Reference: Engineering Services  
105 Meadow Spring Ln.  
Sanford, NC 27332  
TE&D Project No.: 2301-020195

As requested by the builder, a representative of Tyndall Engineering & Design, PA (TE&D) was on-site to observe the following items:

Item 1.b. Install additional 2 x 4 studs packed tightly to corners

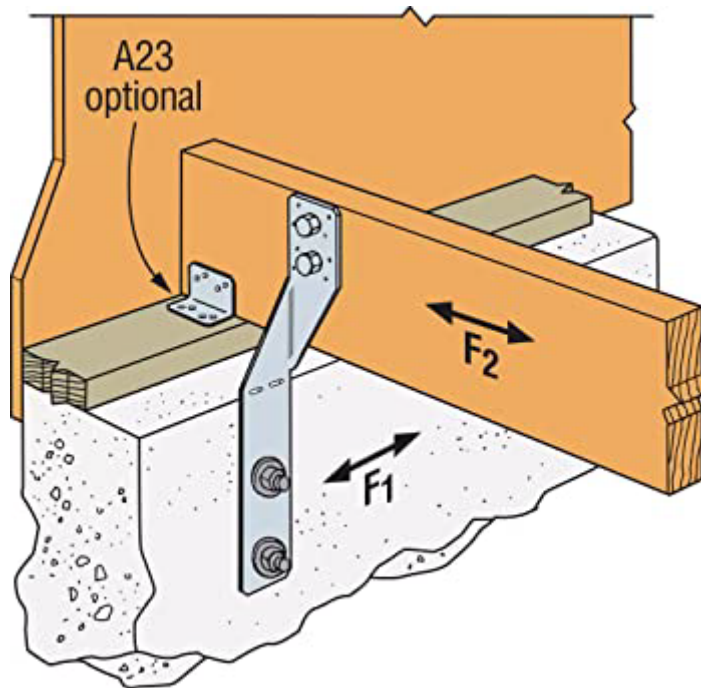
- b. Additional stud columns are to be packed tightly into open space between the windows and the corners.
  - c. The interior of all exterior walls is to be covered with 5/8" structural sheathing. Sheathing is to be secured to all studs and headers with 8D nails at 8" o.c.
